Accredited Standards Committee*
NCITS, Information Technology

Doc. No.: T11.2/01-309v1
Date: Aug 06, 2001
Project: FC0 MJSQ ad hoc
Ref. Doc.:
Reply to: Dennis Petrich
Allen Kramer
Bill Ham

Subject: Approved minutes of T11.2 FC0 MJSQ working group on
June 04, 2001

Figure 1 - Features of jitter distribution to be used for mask placement

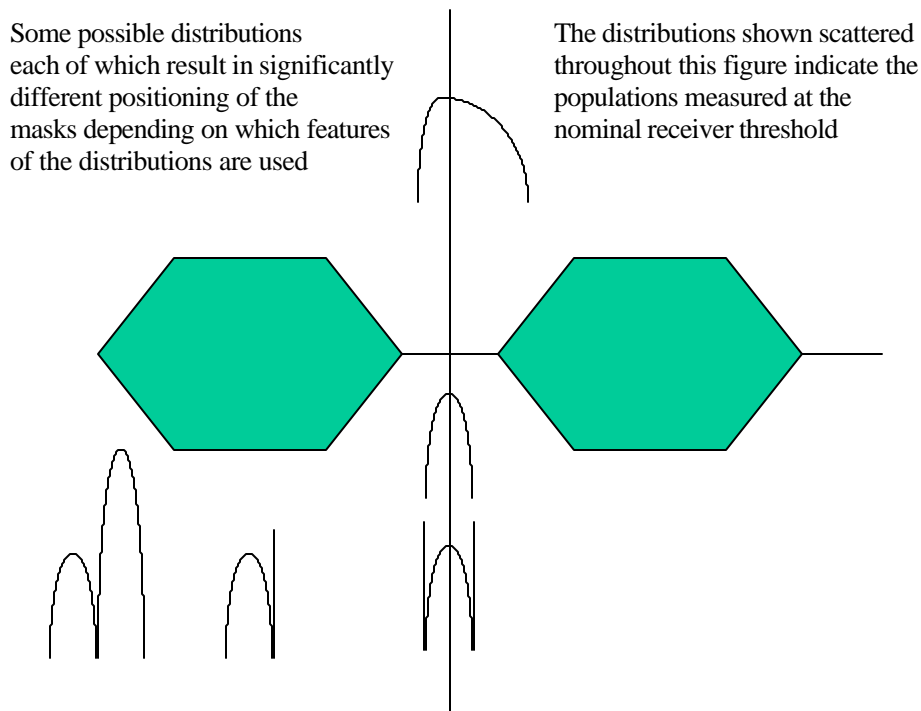
There were three schools of thought brought forward if using the threshold crossing as the timing event:

- (1) Use the mean of the distribution to define the position of the mask and
- (2) Center the mask around the extremes (10**-12 level)
- (3) Fit the mask within the distribution if possible (after discussion this one was determined to be essentially the same as (2) and therefore will not be pursued)

- (4) Optimize the position of the mask with respect to the entire data distribution (time axis translations only).

The choice of method is expected to have major consequences on actual pass/fail for several practical applications. How the receiver centers itself is a key part of this issue.

Motion Petrich/Jenkins the MJSQ requires that if the position of the mask with respect to the entire data distribution (time axis translations only) can be adjusted such that there is acceptably low population within the mask then a pass condition exists. This criteria applies to all interoperability points.
